Access Compliance Report

Public Rights-of-Way

(Curb Ramps)

Intersection ID: 48855	Main Street: NEELY_GLEN_DR	Cross Street: SLEDGE_RD	Location: S
ADA ID: 11BFC8198502	Ramp Type: PerpDiag	Initial Pass/Fail: Fail	Overall Compliance: No
Severity Score: 10			
Codes/Mitigation Info/Possible Solution		Field Measurements/Component Compliance

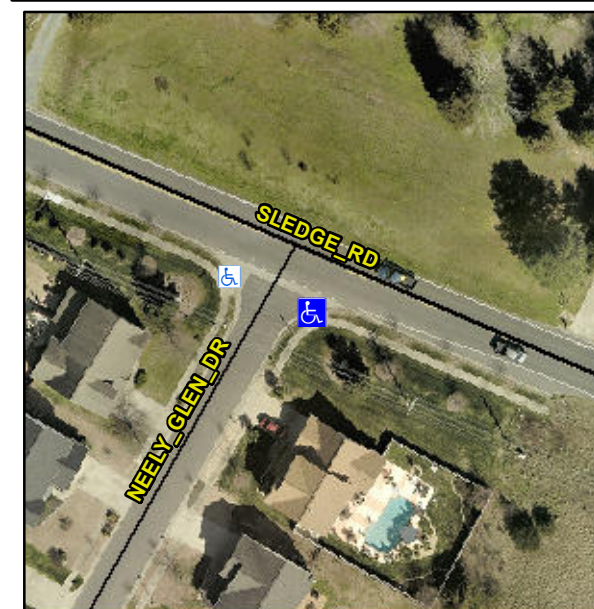
R304.5.1, R304.5.3

Compliance	Description	Data	Compliance	Description	Data
N/A	Ramp Length (in)	95.0	Yes	Ramp Slope (%)	5.3
No	Ramp Width (in)	42.0	No	Ramp XSlope (%)	4.1
N/A	Flare Type LT	N/A	N/A	Flare Type RT	N/A
N/A	Flare Slope LT (%)	N/A	N/A	Flare Slope RT (%)	N/A
N/A	Flare Traversable LT?	N/A	N/A	Flare Traversable RT?	N/A
N/A	Landing Length (in)	N/A	N/A	DWS Provided?	N/A
N/A	Landing Width (in)	N/A	N/A	DWS Contrast?	N/A
N/A	Landing Slope (%)	N/A	N/A	DWS Length (in)	N/A
N/A	Landing X Slope (%)	N/A	N/A	DWS Full Width?	N/A
N/A	Landing Curb? (Y/N)	N/A	N/A	DWS Offset (in)	N/A
N/A	Shared Landing?	N/A			
N/A	Gutter Ponding?	N/A	N/A	Gutter Slope (%)	N/A
N/A	Gutter Lip Ht (in)	N/A	N/A	Gutter X Slope (%)	N/A
N/A	Painted X Walk1?	No	N/A	Painted X Walk2?	No
	X Walk 1 Direction	To NE		X Walk 2 Direction	To NW
N/A	X Walk 1 Width (in)	N/A	N/A	X Walk 2 Width (in)	N/A
	X Walk 1 Slope (%)	4.8		X Walk 2 Slope (%)	2.1
	X Walk 1 X Slope (%)	0.1		X Walk 2 X Slope (%)	5.0

N/A	Ramp inside XWalk1?	N/A	N/A	Ramp inside XWalk2?	N/A
	Road Slope (%)	4.5	N/A	Clear Space?	N/A
	Road X Slope (%)	4.4	N/A	Clear Space to XWalk (in)	N/A
N/A	Any Obstructions?	N/A	N/A	Storm Grate/Utility Hazard?	N/A
	Obstruction Type			Storm Grate/Utility Type	
		N/A			N/A
			Yes	Surface Condition? (G/P)	Good

Remove & Replace Curb Ramp With Two New Directional Ramps or Equivalent.
